# Assessment Officer Report

PA2302446-1 – St Leonards  
College – 10 Killeen Ave  
Brighton

Officer Assessment Report  
Development Approvals & Design

Department  
of Transport  
and Planning

**Proposed extent of changes and demolition**

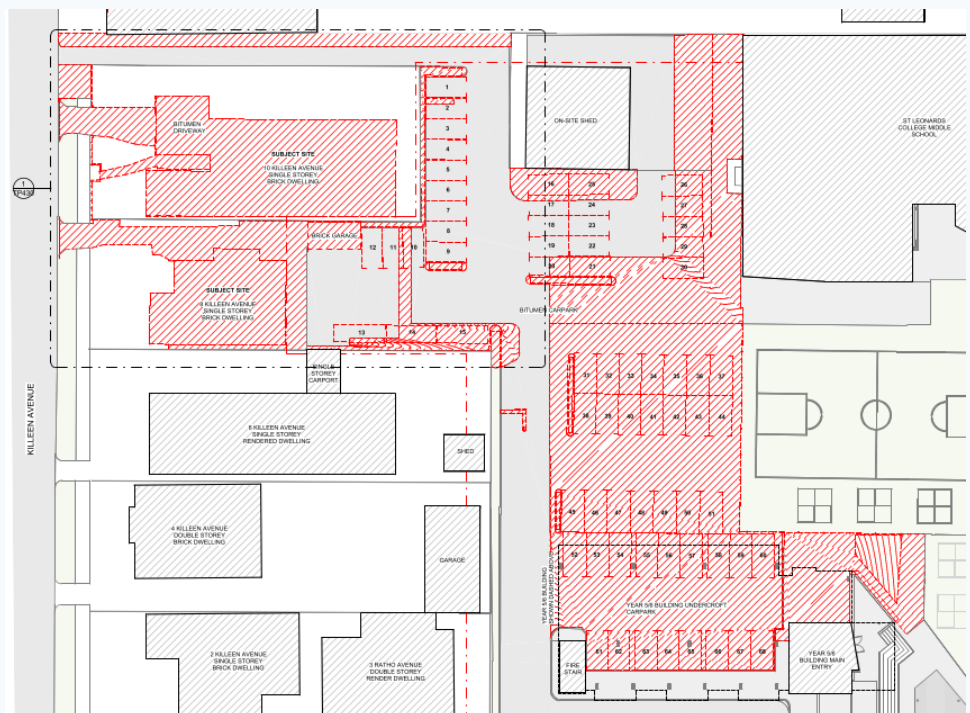
Change / Comment	
<b>Proposed Change</b>	Improvements to the existing school pool façade, new pool reception and airlock.
<b>Assessment</b>	<p>The southern and western facades of the 'Hawkes Centre' swimming pool are proposed to be demolished in addition to pathways and some landscaping to allow for new buildings and works to build a new pool reception area, new south stairway, new gate house with green roof, new entry gate and palisade fence to the vehicle entry and new landscaping and associated seating.</p> <p>The current pool structure is elevated due to the Melbourne Water flooding issues through the area, the swimming pool structure will remain elevated, however the proposed pool reception is set below the flood level and will require changes to meet Melbourne Water conditions which are to be included in the amended permit.</p>

**Indicative extent of new hard courts and play area.**

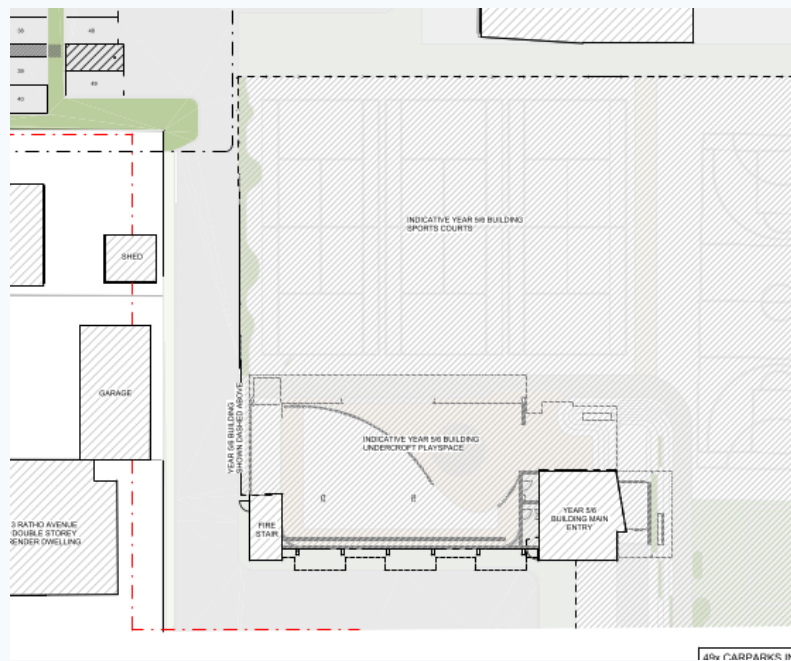
The changes results in a net gain of 3 car parking spaces across the site and will allow the school to increase the extent of hard-court playing fields for students and provide a new undercover play area under the grade 5/6 building through the removal of the car parking currently located in this area. The extension of the hardcourts can be approved and will improve internal amenity for students.

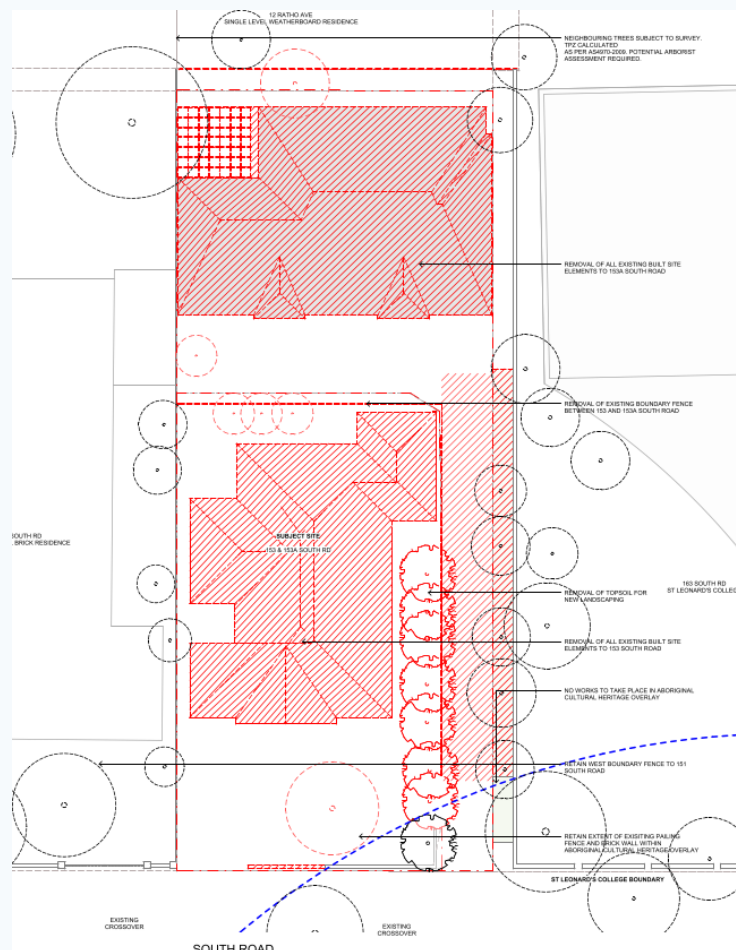
The applicant has requested a new, widened crossover to Killeen Avenue to provide vehicle access to the proposed car parking arrangements. This request is recommended for refusal due to the unreasonable amenity impacts it would create for adjoining residential properties located directly opposite the proposed crossover.

In contrast, the introduction of a new vehicle access to Killeen Avenue would result in significant traffic, safety, and amenity impacts for residents along this narrow residential street, representing a substantial change to existing conditions. These concerns have been raised consistently through multiple objections from affected residents.

Killeen Avenue has limited opportunities for vehicles to pass when on-street parking occurs on both sides of the road. Objectors have expressed concern that increased vehicle movements associated with the proposed car park (particularly during school peak periods) would create unacceptable safety risks for children using the footpaths. With the removal of the former dwellings that previously provided a buffer between the school and neighbouring residences, and the proposed alteration to

vehicle access arrangements, the resultant impacts on residential amenity are considered significant. The removal of the dwellings to create the car parking will allow the opportunity for the crossovers to be removed along the Killeen Avenue frontage increasing on street car parking. Conditions will be included in the amended permit requiring the removal of the vehicle access to Killeen Avenue, and reinstatement of council assets.

- b. **remove all vehicle access from Killeen Avenue to the Killeen Avenue carpark, all access to be via the current access arrangements located in Ratho Avenue. remove redundant crossovers located on Killeen Avenue, kerb and channel and nature strip to be reinstated.**
  - h) **The landscaping plans prepared by Urbis, 'South Rd & Killeen Ave carparking', dated 25/09/2025, updated to reflect any changes to development plans.**
  - i) **The plans prepared by Forum Studio, the 'Gate House' dated 23/07/2025, amended to show the FFL of the gatehouse to ensure that the FFL meet Melbourne Water conditions.**
  - j) **The provision of a Parking Management Plan.**
4. The development as shown on the endorsed plans must not be altered without the written consent of the Responsible Authority.

**Proposed landscaping to car park**

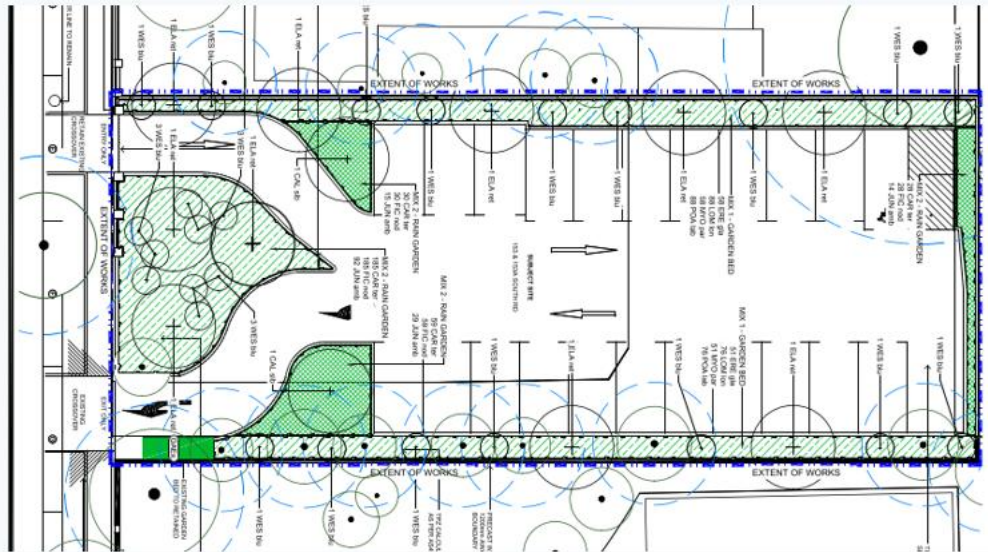
These new car parks go towards replacing the 17 car parking spaces proposed to be removed from the undercroft car park located under the year 5/6 building.

The proposed car park will utilize the existing crossovers to allow for a single entrance into the car park and a separate crossover to exit, this will allow for the existing street trees to be retained with minimal impact.
